Roof Side Weatherstrip - Revised Installation

BO022-00

Title: ROOF SIDE RAIL WEATHERSTRIP POOR RETENTION

Models: '00 Celica

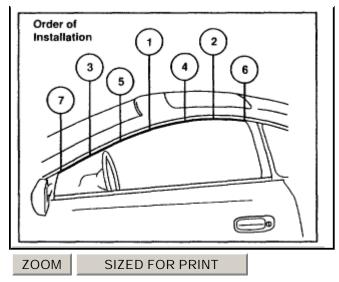
2. If the weatherstrip is in good condition, start by installing the weatherstrip in the No. 2 corner. If the weatherstrip is damaged, replace the weatherstrip.

3. Hook the bottom edge of the weatherstrip into the roof drip side molding first. Then, using your fingers, install the top edge of the weatherstrip into the molding.

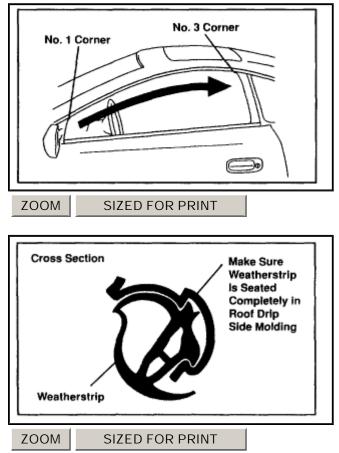
4. Continue to install the weatherstrip by hand in the order shown in the illustration.

5. Using finger pressure, press the length of the weatherstrip between the No. 1 and No. 3 corners to verify that the weatherstrip is seated completely in the roof drip side molding as shown in illustration.
